# Access Compliance Report

## Public Rights-of-Way

Intersection ID: 4232	Main Street: SALOME_CHURCH_RD	Cross Street: STONEY_VIEW_DR	Location: NW
ADA ID: 35BCB01E4223	Ramp Type: Perp	Initial Pass/Fail: Fail	Overall Compliance: No
		Severity Score: 50

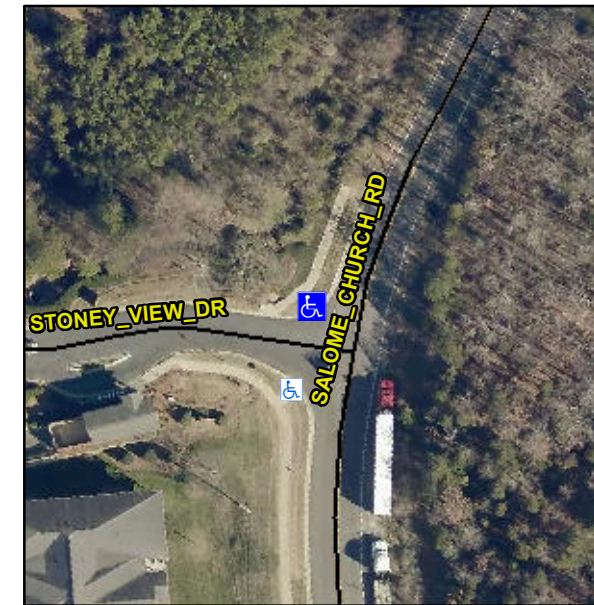
**Not Found, R304.2.2, R304.5.3**

Compliance	Description	Data	Compliance	Description	Data
N/A	Ramp Length (in)	96.0	No	Ramp Slope (%)	12.6
Yes	Ramp Width (in)	52.0	No	Ramp XSlope (%)	8.5
N/A	Flare Type LT	N/A	N/A	Flare Type RT	N/A
N/A	Flare Slope LT (%)	N/A	N/A	Flare Slope RT (%)	N/A
N/A	Flare Traversable LT?	N/A	N/A	Flare Traversable RT?	N/A
N/A	Landing Length (in)	N/A	N/A	DWS Provided?	N/A
N/A	Landing Width (in)	N/A	N/A	DWS Contrast?	N/A
N/A	Landing Slope (%)	N/A	N/A	DWS Length (in)	N/A
N/A	Landing X Slope (%)	N/A	N/A	DWS Full Width?	N/A
N/A	Landing Curb? (Y/N)	N/A	N/A	DWS Offset (in)	N/A
N/A	Shared Landing?	N/A			
N/A	Gutter Ponding?	N/A	N/A	Gutter Slope (%)	N/A
N/A	Gutter Lip Ht (in)	0.5	N/A	Gutter X Slope (%)	N/A
N/A	Painted X Walk1?	No	N/A	Painted X Walk2?	N/A
	X Walk 1 Direction	To S		X Walk 2 Direction	N/A
N/A	X Walk 1 Width (in)	N/A	N/A	X Walk 2 Width (in)	N/A
	X Walk 1 Slope (%)	3.4		X Walk 2 Slope (%)	N/A
	X Walk 1 X Slope (%)	1.6		X Walk 2 X Slope (%)	N/A

**Remove & Replace Entire Ramp.**
